Office Action Summary

10/811,695

KLINE ET AL.

DETAILED ACTION

Fig. 2

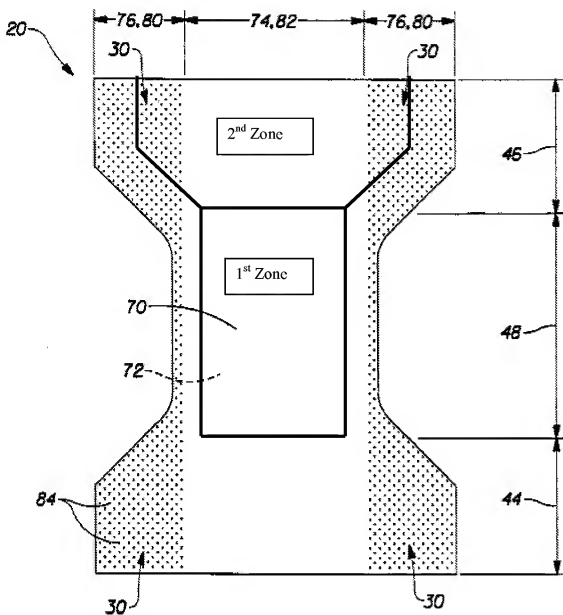
a second stretch region (34, 44) having lateral stretch; wherein said first stretch region is capable of co-elongating with said second stretch region (see annotated figure 2, *infra*, which has lines inserted to define the zones as interpreted herein).

Drobin teaches that the apertures may be formed by cutting holes out of a film without forming cones, such that the apertures will have a caliper the same as the film thickness, which necessarily means that some material will be removed from the film leaving it with a decreased density and basis weight (col. 9, lines 28-30). The result is that the unperforated portion (82) of the backsheet (26) has a greater basis weight and density than the perforated portions (80). First backsheet zone (46) has a much larger area that is perforated than second backsheet zone.

Applicants assert that Dobrin does not disclose a second backsheet zone of relatively lower basis weight disposed within a laterally central region of a backsheet. Applicants further assert that Dobrin's apertured zones are outside of the central region of the backsheet. This argument is not persuasive because the second zone is now considered to be the area defined in annotated fig. 2, *supra*, which contains the apertures. It is noted that applicants' specification

describes the central region as overlapping the longitudinal centerline which is met by and does not preclude the interpretation used herein (see applicants' published application, US 2005/0215970, ¶s 0007 & 0049). Thus the unapertured first zone would have a higher basis weight than the apertured second zone.
